HISTORIC AND DESIGN REVIEW COMMISSION

HDRC CASE NO: 2019-357
ADDRESS: 831 LAMAR ST
LEGAL DESCRIPTION: NCB 1368 BLK 5 LOT 21
ZONING: R-6, H
CITY COUNCIL DIST.: 2
DISTRICT: Dignowity Hill Historic District
APPLICANT: Octavio Viramontes/HACAM PROPERTIES LLC
OWNER: Octavio Viramontes/HACAM PROPERTIES LLC
TYPE OF WORK: Construction of a 1-story, single family residential structure
APPLICATION RECEIVED: July 26, 2019
60-DAY REVIEW: August 20, 2019
CASE MANAGER: Edward Hall
REQUEST:

The applicant is requesting a Certificate of Appropriateness for approval to construct one, 1-story single-family residence on the vacant lot at 831 Lamar, located within the Dignowity Hill Historic District.

A-2 / 4

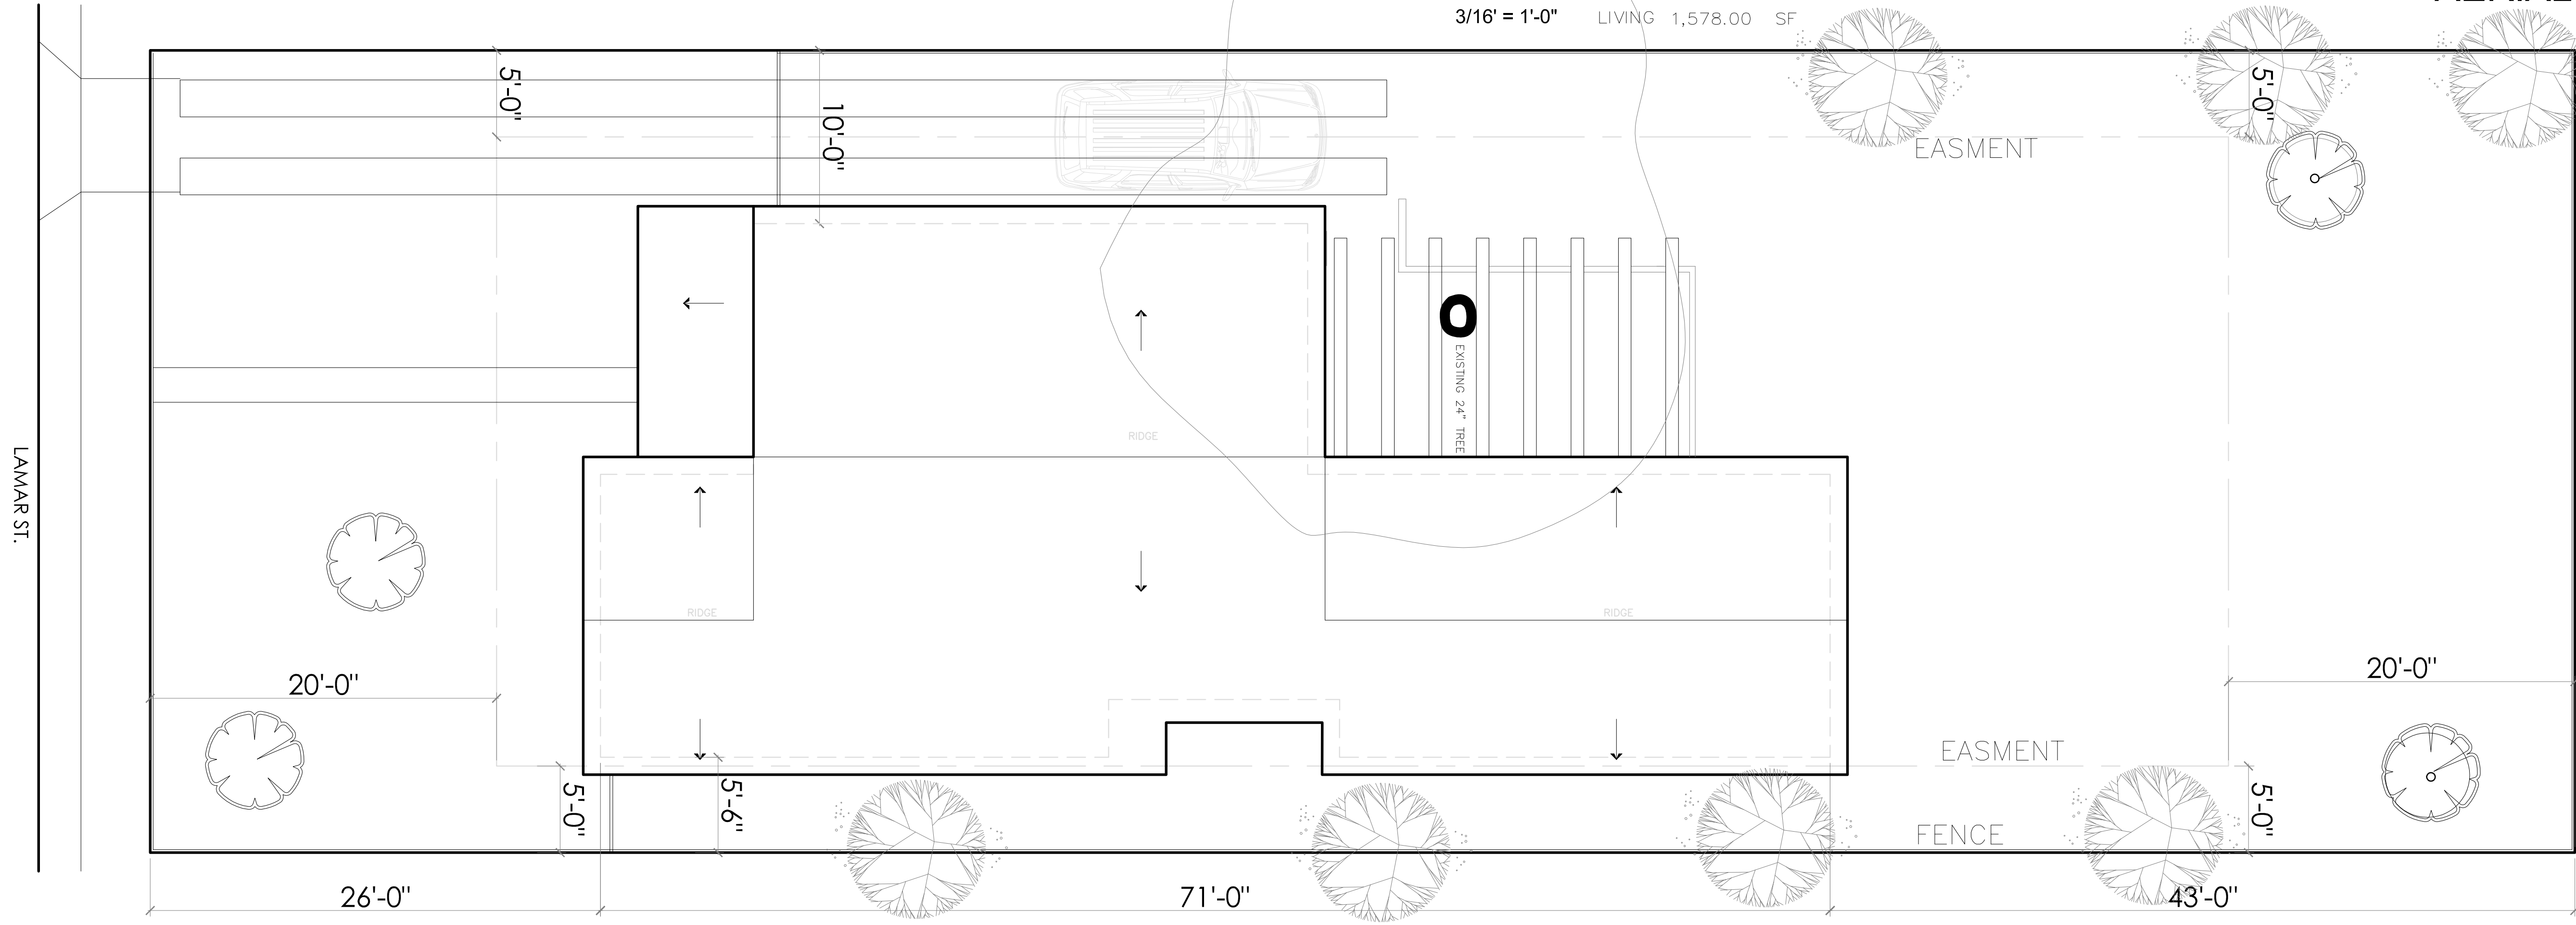
- i. That the applicant provide additional setback information to confirm that a setback that is greater than that of the historic structure to the immediate west is used. **The applicant has submitted an updated setback diagram that notes that a greater setback is proposed.**

- f. SETBACKS & ORIENTATION – According to the Guidelines for New Construction, the front facades of new buildings are to align with front facades of adjacent buildings where a consistent setback has been established along the street frontage. Additionally, the orientation of new construction should be consistent with the historic examples found on the block. Per the submitted setback diagram, the applicant has proposed a setback that is greater than that of the adjacent historic structure to the immediate west. The structure to the east was constructed circa 1957 and does not feature elements that are typical of the Dignowity Hill Historic District.

A-3 / 4

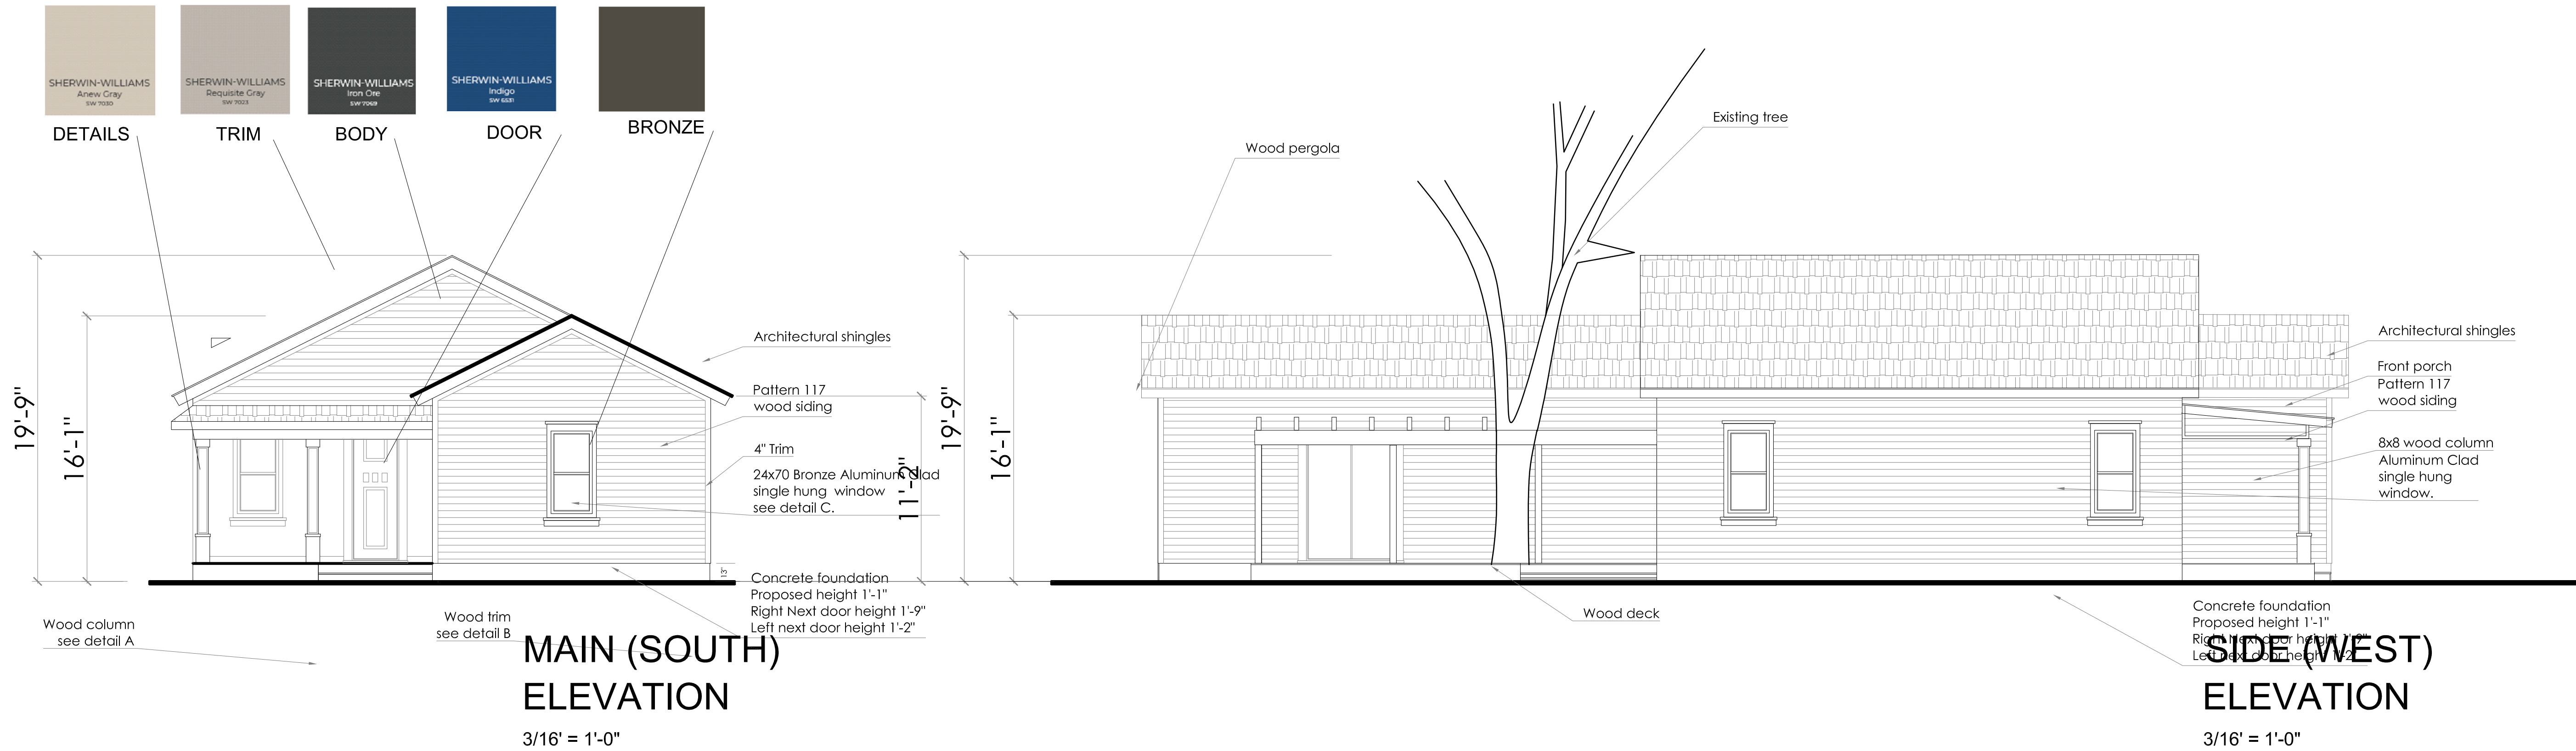
- ii. That the applicant confirm the proposed foundation height is within one (1) foot of those found historically on the block. **The applicant has noted a foundation height of 1' – 1".**

- iii. That the applicant increase window heights to be more consistent with those found historically in the district. **The applicant has noted the installation of windows with heights of seventy (70) inches.**

- vi. That the applicant lower the top plate of each wall to eliminate excess wall height, which will result in a proportionate façade arrangement. **The applicant has complied with this stipulation.**

- j. ROOF FORM – The applicant has proposed roof forms that include front facing gabled roofs and a shed porch roof. Both of these roof forms, in this context, are found historically within the Dignowity Hill Historic District. Staff finds the proposed roof forms to be appropriate.

- m. WINDOW MATERIALS – The applicant has proposed aluminum clad wood windows. Staff finds the proposed windows to be appropriate; however, meeting rails must be no taller than 1.25" and stiles no wider than 2.25". White manufacturer's color is not allowed, and color selection must be presented to staff. There should be a minimum of two inches in depth between the front face of the window trim and the front face of the top window sash. This must be accomplished by recessing the window sufficiently within the opening or with the installation of additional window trim to add thickness. Window trim must feature traditional dimensions and architecturally appropriate sill detail. Window track components must be painted to match the window trim or concealed by a wood window screen set within the opening.

- i. That the applicant ensures that the proposed aluminum clad wood windows meet the following specifications: Meeting rails must be no taller than 1.25" and stiles no wider than 2.25". White manufacturer's color is not allowed, and color selection must be presented to staff. There should be a minimum of two inches in depth between the front face of the window trim and the front face of the top window sash. This must be accomplished by recessing the window sufficiently within the opening or with the installation of additional window trim to add thickness. Window trim must feature traditional dimensions and architecturally appropriate sill detail. Window track components must be painted to match the window trim or concealed by a wood window screen set within the opening.

LANDSCAPING PLAN

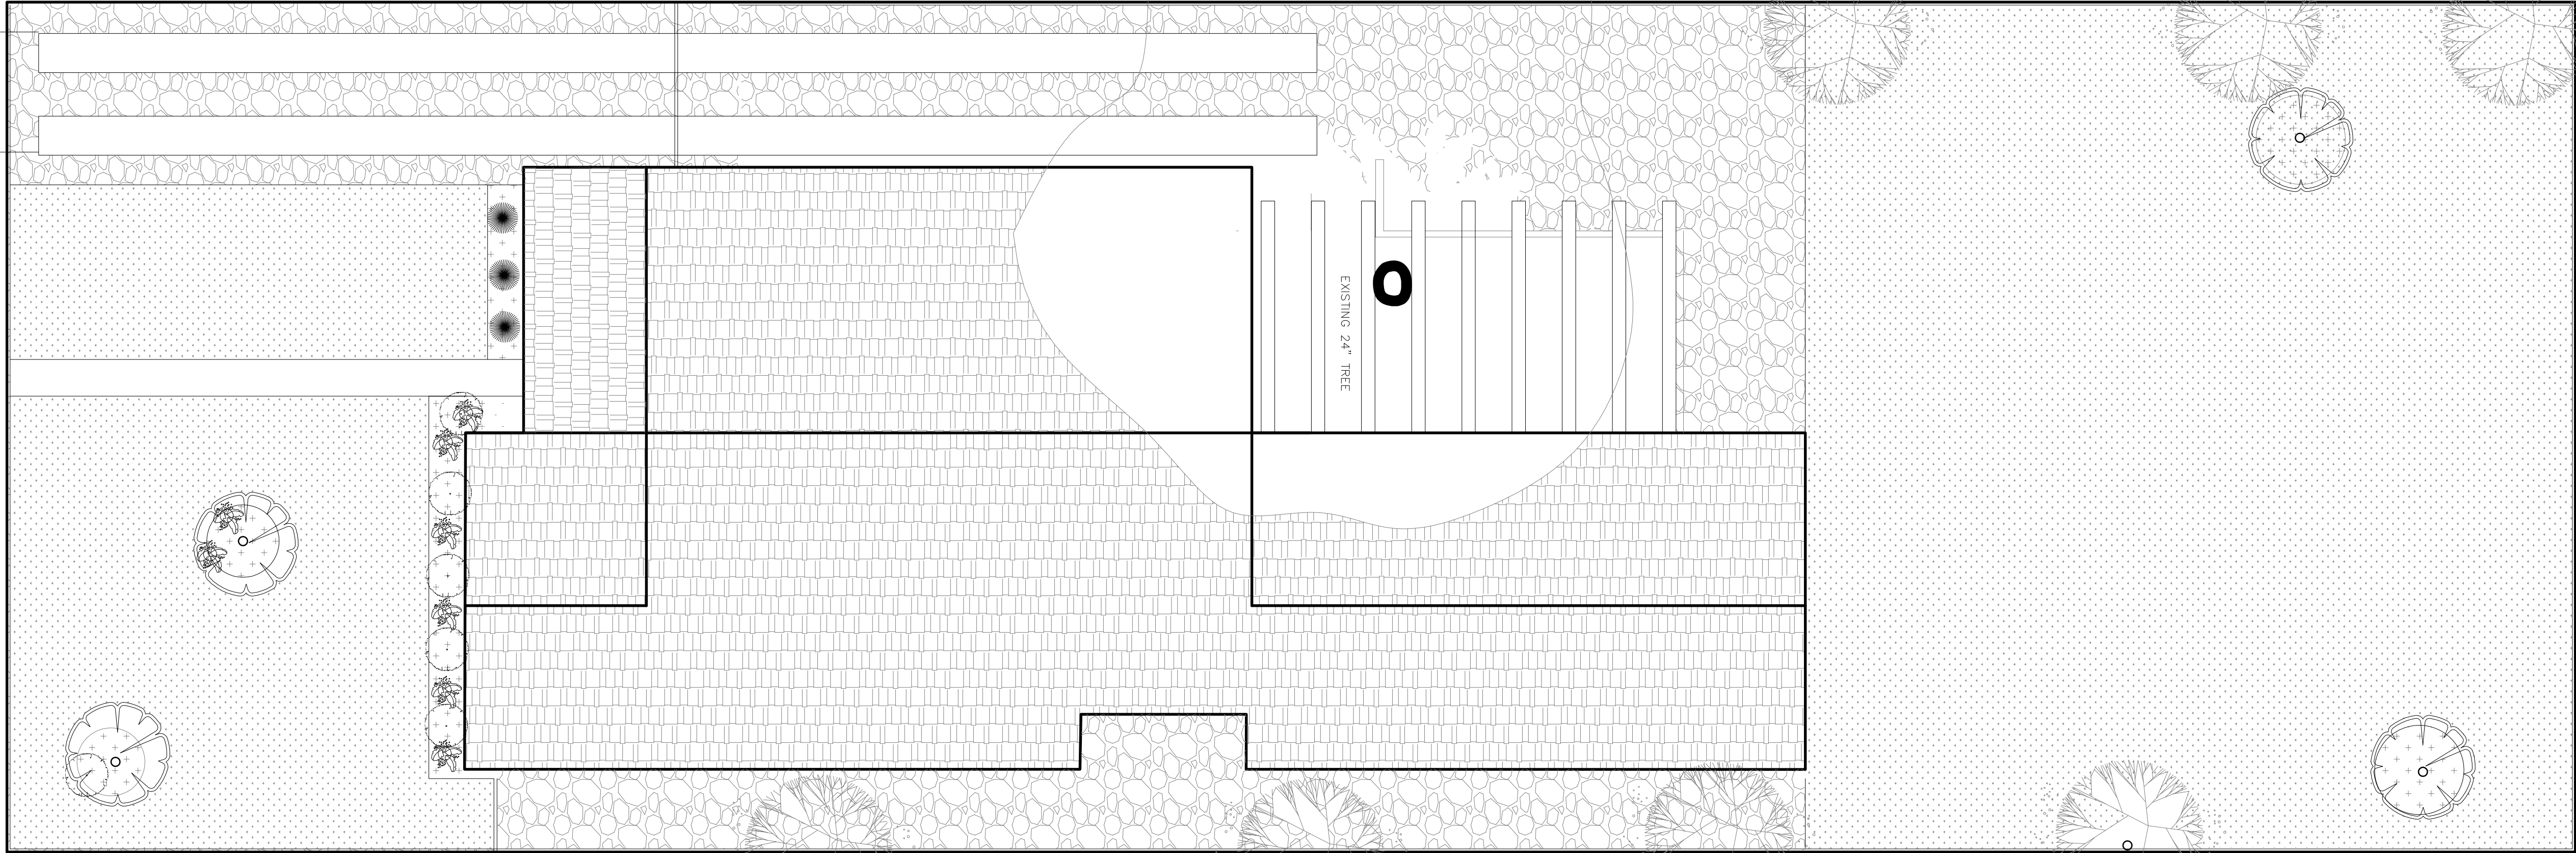
- vii. That the applicant submit a detailed landscaping plan for review and approval. **The applicant has submitted a landscaping plan.**
 - viii. That the location of the existing, rear yard pecan tree be confirmed. **The applicant has confirmed the location of the existing pecan tree and has noted its location on both site and landscaping plans.**

- p. LANDSCAPING – The applicant has submitted a landscaping plan that staff finds to be appropriate and consistent with the Guidelines.
